Re: File # V22-23 REV-2. Revised 4-6-23.

Summary: To allow encroachment into the City's 25ft. impervious stream bank buffer

Variance application by Kerley Family Homes, for two properties located at 21 & 23 Ashwood Drive and zoned R-20 (Single Family Residential) and P-D (Planned Development). Both properties contain approximately 0.2 acres. These lots are currently undeveloped.

Subject: [EXTERNAL] Carter's Grove Lots J1379 & J1380

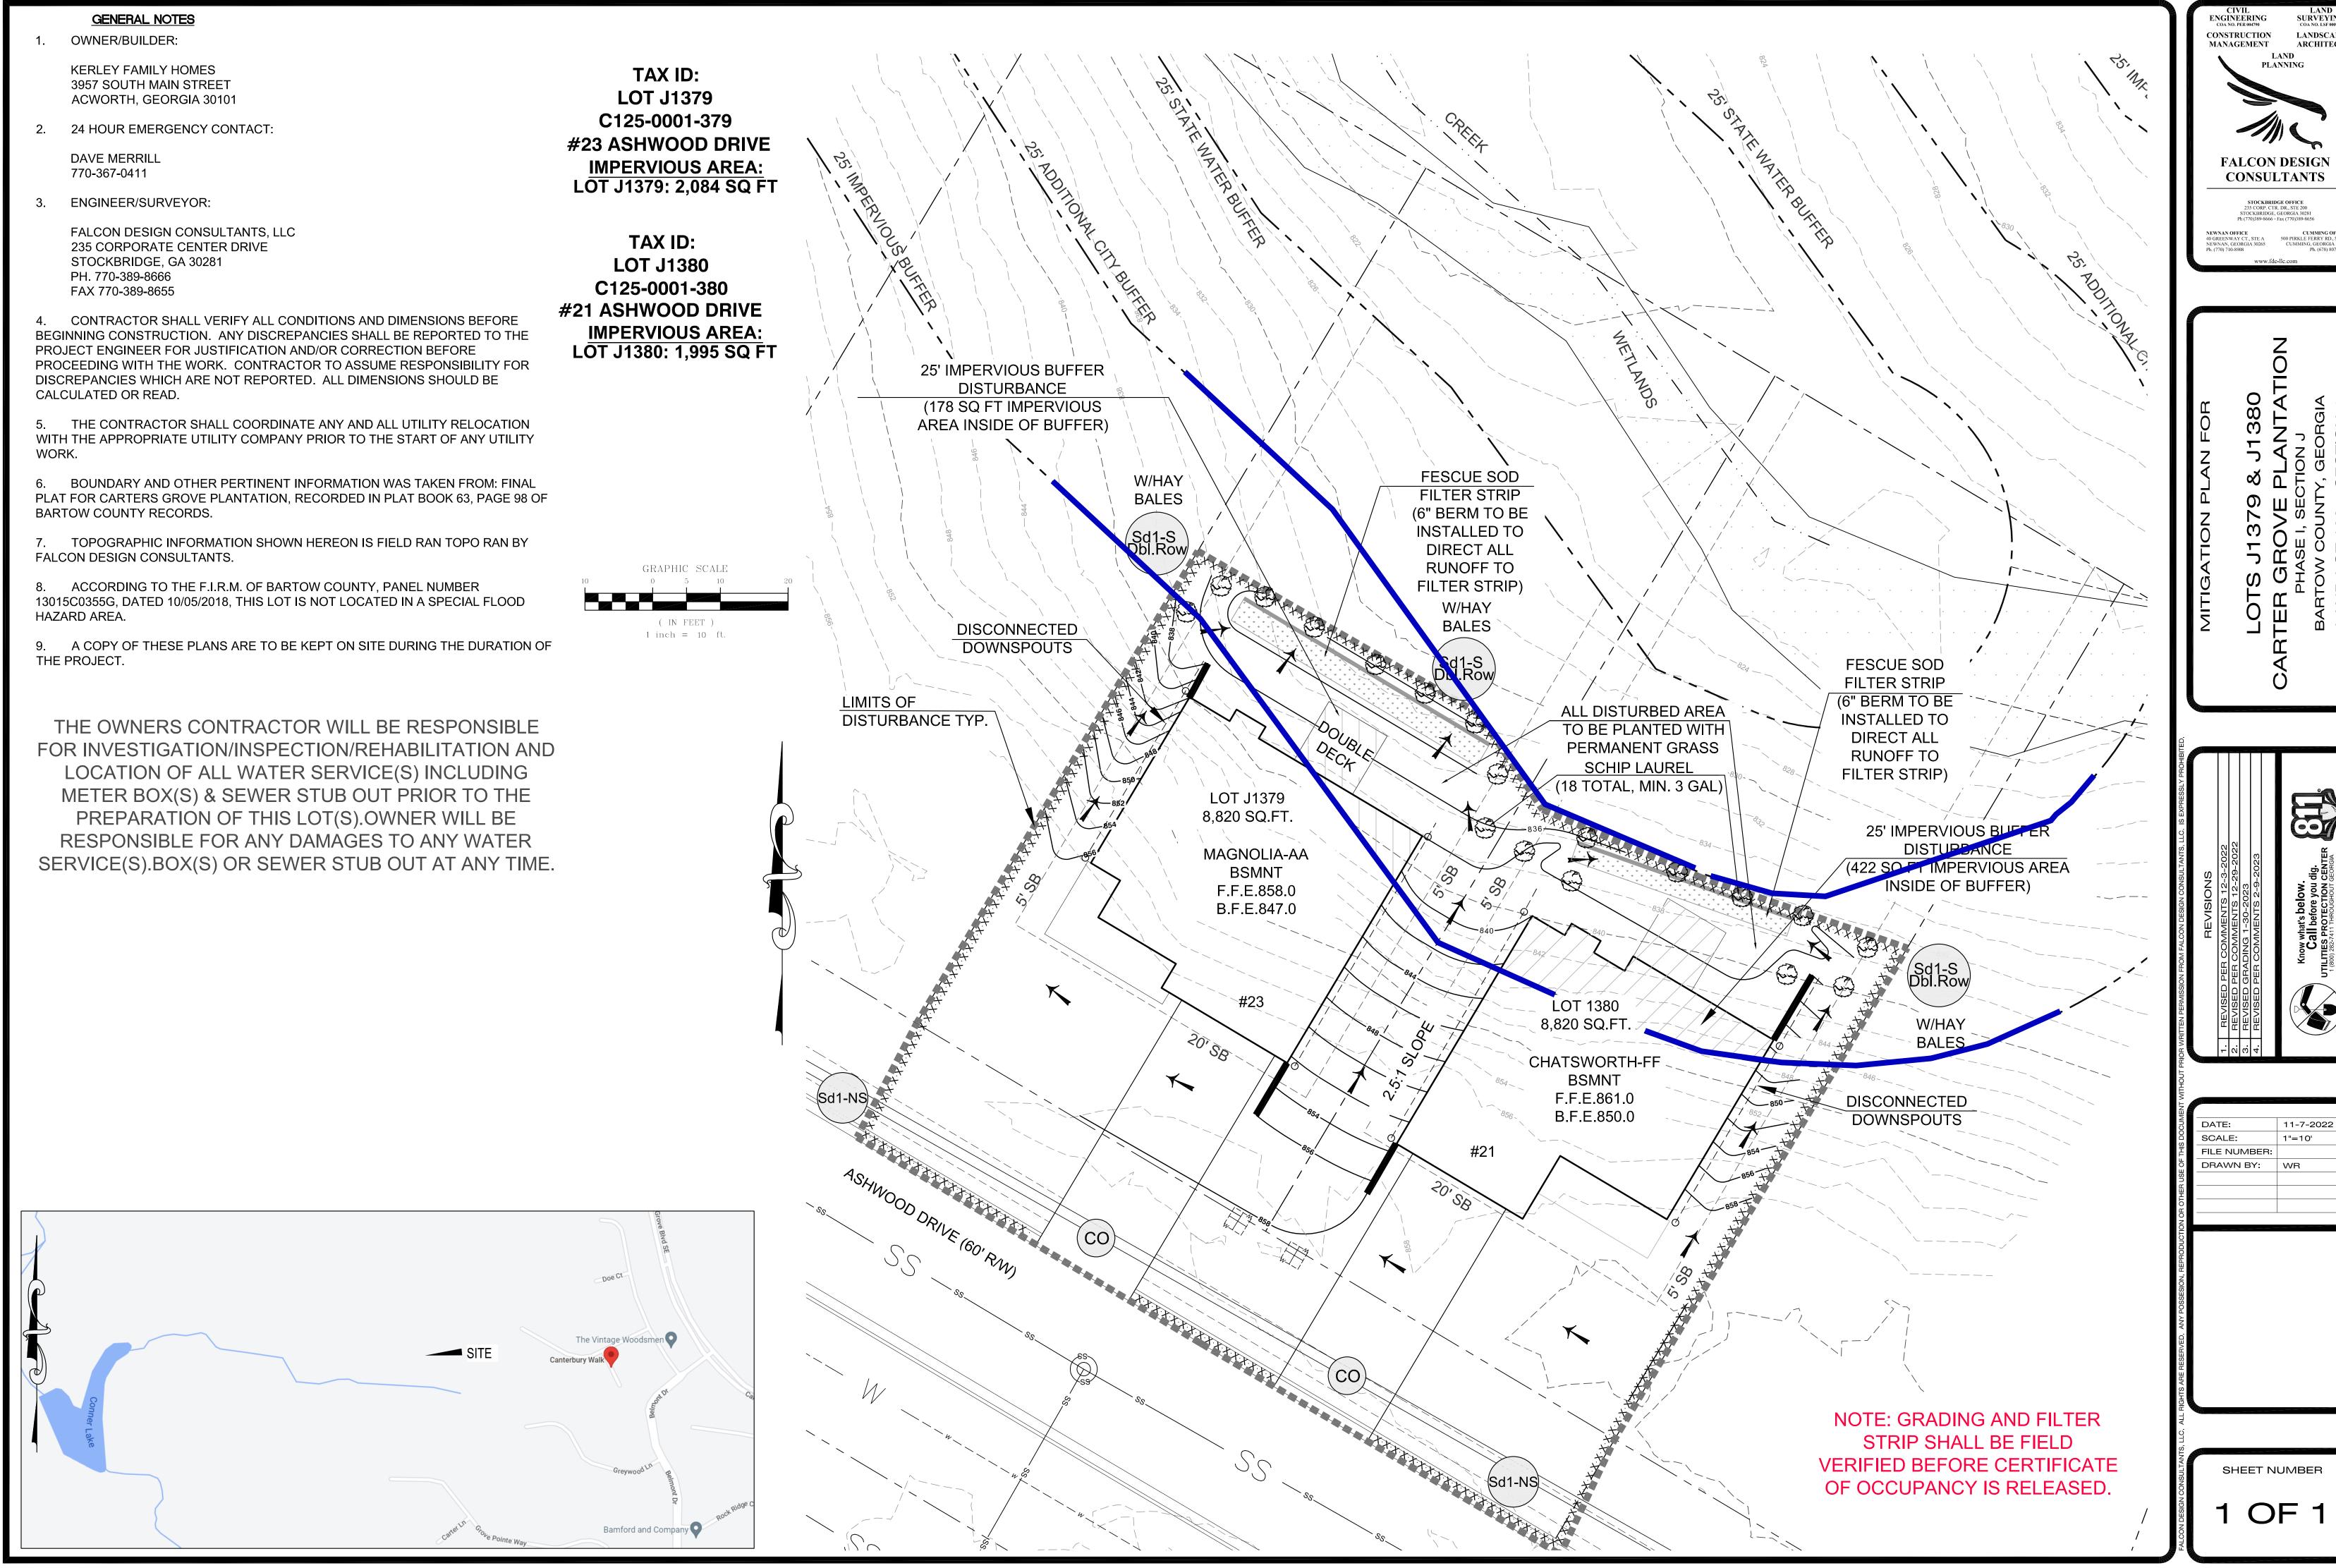
Please see attached revised mitigation plan. We revised the filter strip from Bermuda to Fescue, added a note to notate a berm to direct all runoff of the filter strip, and added a note stating lots shall be field verified before a CO will be released. Please let me know if any other changes need to be made. Thanks.

The proposed mitigation for the subject lots are acceptable to Public Works.

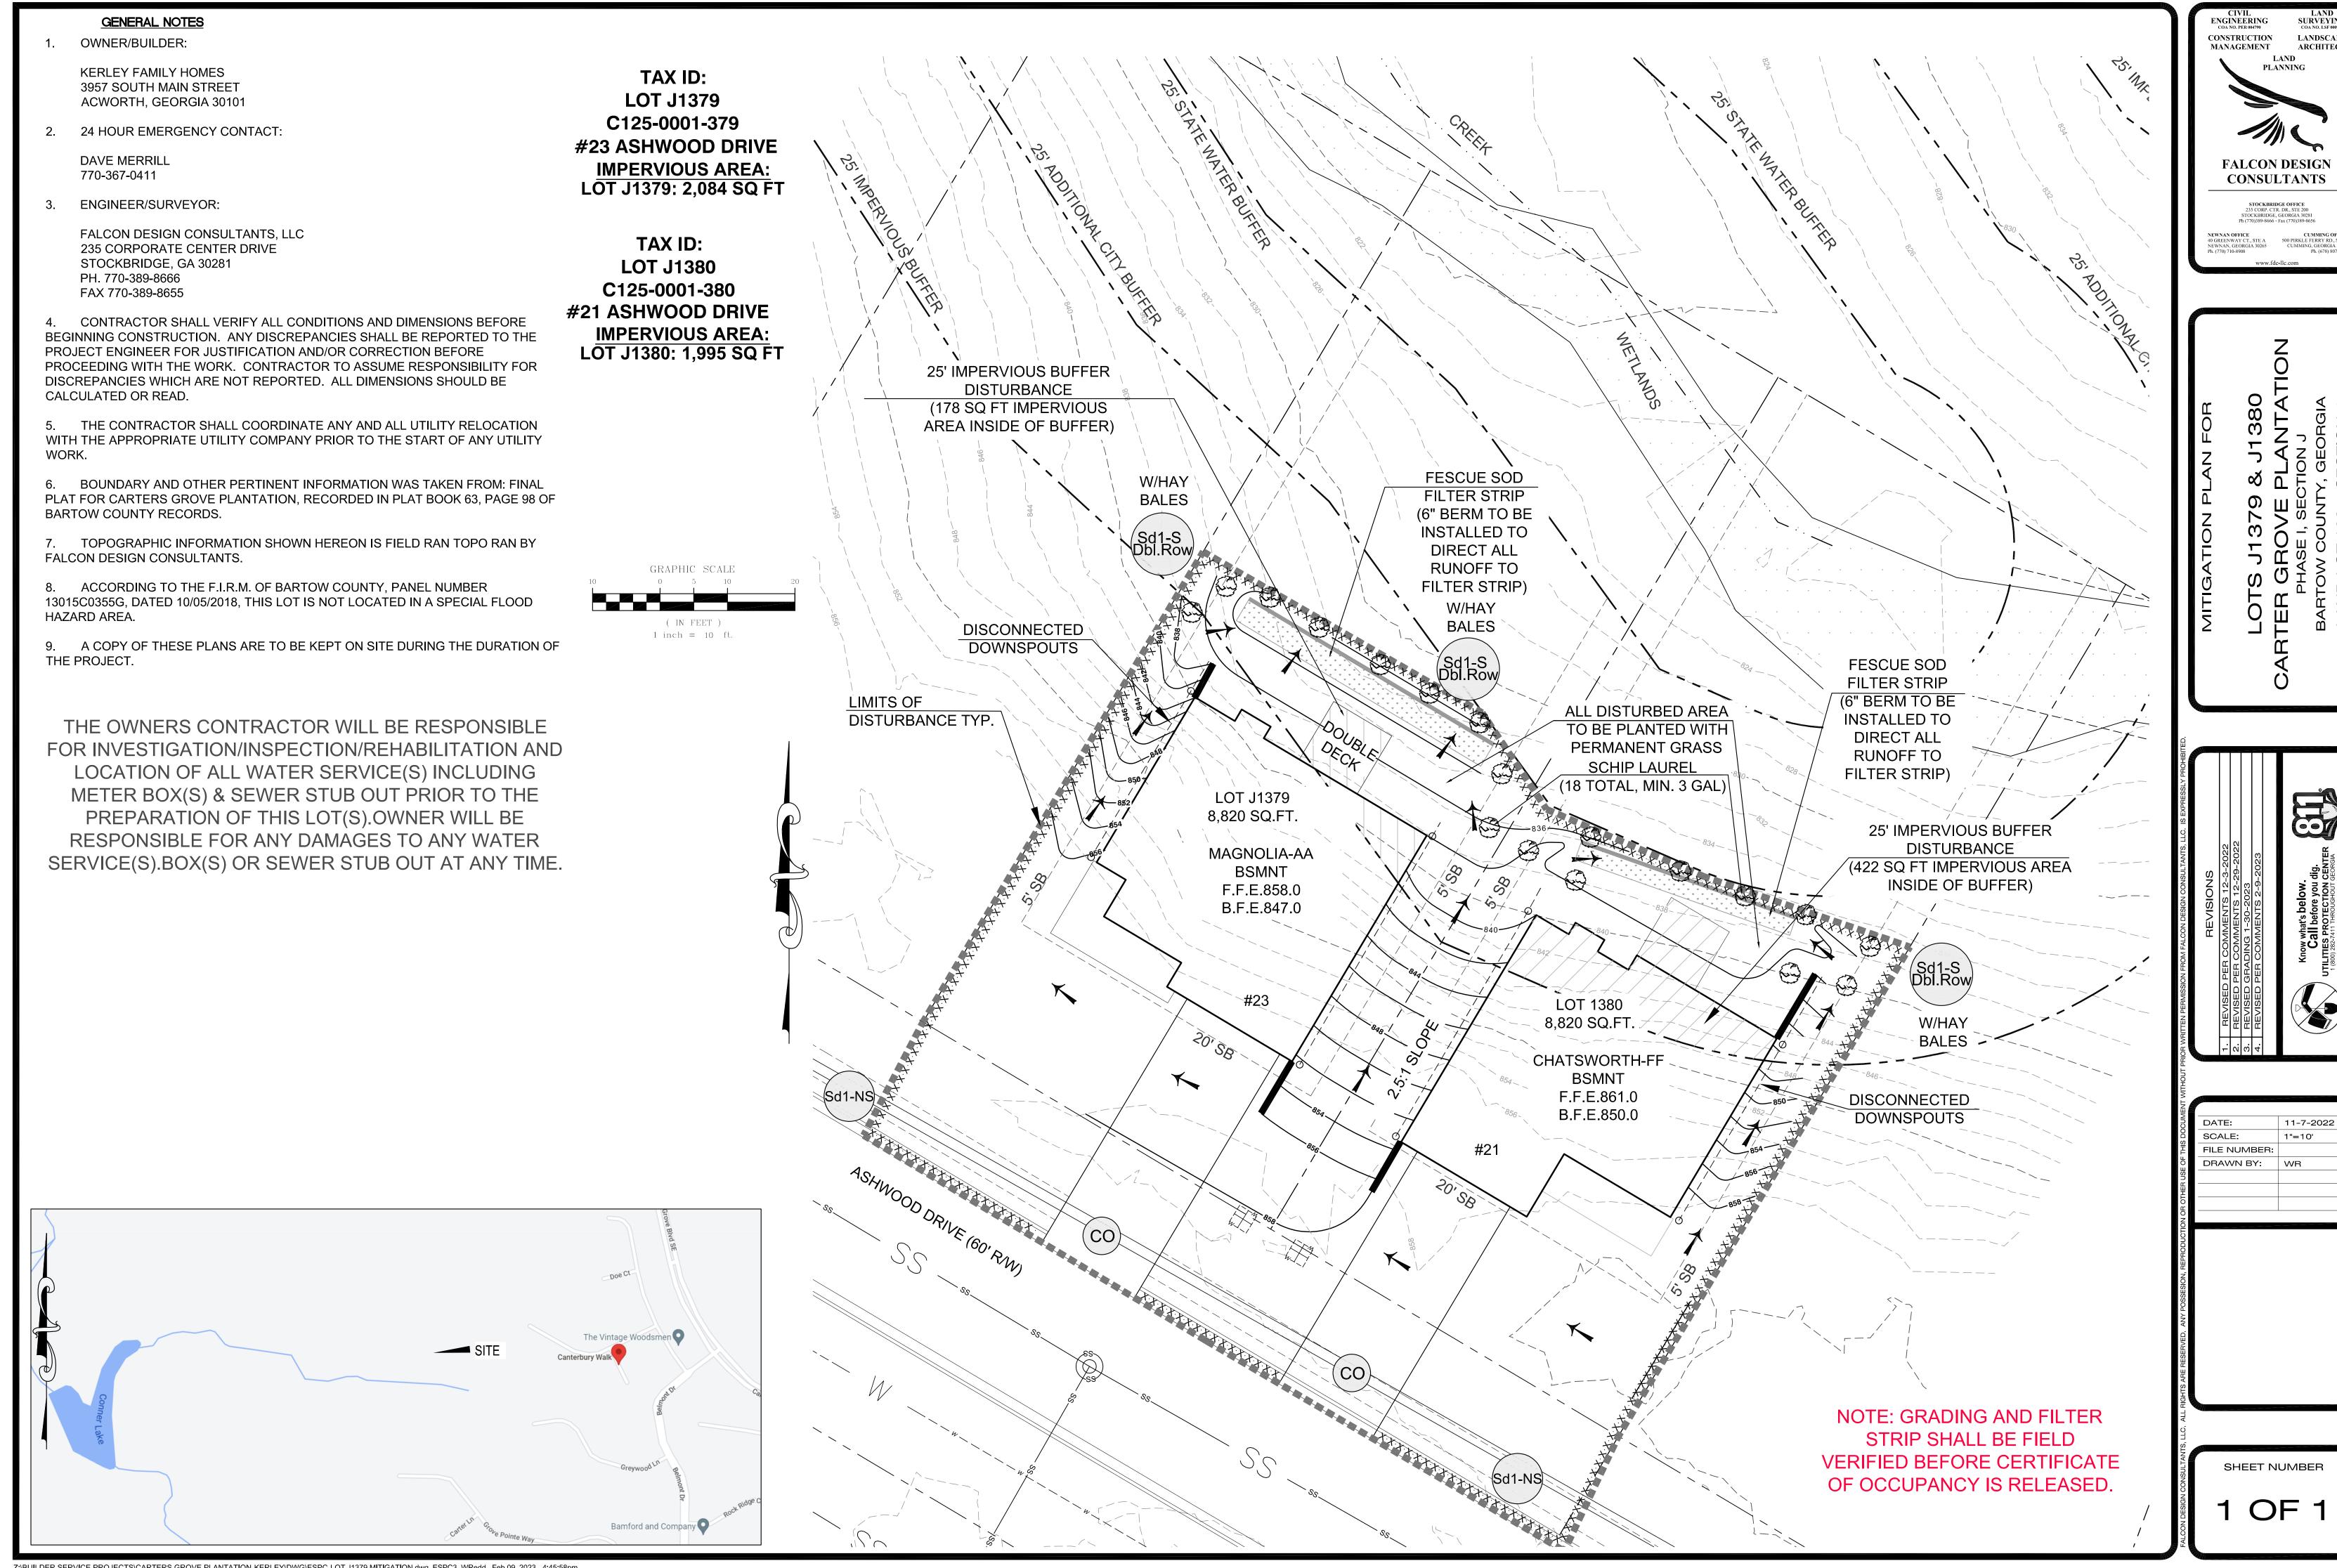
For lot J1379 – The back right corner of the proposed home and the deck encroach a total of 13.1' on the 25' impervious buffer (178 sqft impervious area inside of buffer)

For lot J1380 – The back of the proposed home and the deck encroach a total of 18.2' on the 25' impervious buffer. (422 sqft impervious area inside of buffer)
